HISTORIC AND DESIGN REVIEW COMMISSION

HDRC CASE NO: 2019-247
ADDRESS: 909 N HACKBERRY ST
LEGAL DESCRIPTION: NCB 529 BLK 2 LOT N 92.5 FT OF 13 & 14
ZONING: IDZ, H
CITY COUNCIL DIST.: 2
DISTRICT: Dignowity Hill Historic District
APPLICANT: Haley Serna/Open Studio Architecture
OWNER: Michael & Teresa Garansuay
TYPE OF WORK: Construction of 2, two-story, residential structures, and two rear residential structures
APPLICATION RECEIVED: April 30, 2019
60-DAY REVIEW: June 28, 2019
CASE MANAGER: Edward Hall
REQUEST:

DIGNOWITY TOWNHOMES

SITE PLAN
SCALE: 1:10

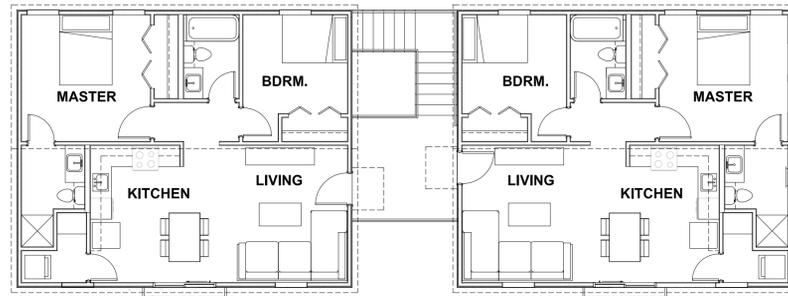
- d. **DESIGN UPDATES** – The applicant has updated the proposed site plan, which per Zoning staff constitutes a major plan amendment and would require rezoning.

- e. **LOT COVERAGE** – Per the Guidelines, the building footprint for new construction should be no more than fifty (50) percent of the size of the total lot area. The applicant has proposed footprints for four structures which is atypical of the historic development pattern within the district. The applicant is responsible for complying with the Guidelines and ensuring that the proposed lot coverage does not exceed fifty (50) percent.

- f. **VEHICULAR ACCESS** – The applicant has proposed vehicular access into the site from Fayn Way. The Guidelines for Site Elements 5.B.i. notes that a similar driveway configuration to those that are found historically within the district should be used for new driveways. Typically, driveways are ten (10) feet wide within the Dignowity Hill Historic District. The applicant has proposed an initial curb cut and driveway with that is comparable to those found historically within the district.

- g. **SITE PAVING** – The applicant has proposed an amount of site paving that per the submitted site plan, appears inconsistent with the amount of site paving that is found historically within the Dignowity Hill Historic District. The applicant has proposed pervious paving on site.

- 1c. **SETBACKS (Fayn Way)** – The applicant has not noted a side setback on Fayn Way. On this block, Fayn Way connects N Hackberry to N Mesquite. There are no primary historic structures that feature a front orientation toward Fayn Way. On other block, such as across N Hackberry at N Hackberry and Fayn Way, historic structures feature a minimal side setback from the Fayn Way, approximately ten (10) feet.

- 1e. **BUILDING SPACING** – The applicant has proposed spacing between the two primary structures that approximately eight (8) feet; less than that which is found historically within the Dignowity Hill Historic District. Staff finds that additional building should be incorporated into the design.

- 2b. SETBACKS & ORIENTATION – The Guidelines for New Construction 5.B. notes that the predominant orientation of accessory structure should be matched. Additionally, the historic setback patterns found historically within the district should be used. Generally, accessory structures within the Dignowity Hill Historic District are located in the rear corners of lots. Accessory structures that span the entire length of the property line, as proposed, are generally inconsistent with the historic development pattern for accessory structures within the District and inconsistent with the Guidelines.

- 2c. SCALE & MASS – Per the Guidelines for New Construction 5.A.i. accessory structures should be designed to be visually subordinate to the principal historic structure in terms of their massing, height and form. While the proposed accessory structures may feature a height, width and massing that are subordinate to the proposed new construction requested in item one, staff finds the proposed massing to be inconsistent with the historic examples found in the immediate vicinity for accessory structures, which are all one story in height. Additionally, staff finds the proposed footprint of the rear accessory structures to be inconsistent with the Guidelines.

- i. That the applicant ensure that lot coverage does not exceed more than fifty (50) percent as noted in finding d.
- ii. That the applicant install a driveway and site paving that are consistent with the Guidelines and the historic examples found throughout the Dignowity Hill Historic District as noted in findings e and f.

- iii. That all mechanical equipment be screened from view from the public right of way as noted in finding g.
- iv. That the applicant submit a site plan or a setback diagram which notes the proposed setback is appropriate and consistent with the Guidelines as noted in finding 1b and 1c.

- v. That the applicant either reduce the proposed massing. As proposed, the massing is not appropriate for this lot.
- vi. That the applicant provide a large separation between structures as noted in finding 1e.

- xi. That the applicant reduce the massing and height of the proposed rear structures and incorporate setbacks and orientations that are consistent with the Guidelines as noted in findings 2a through 2d.
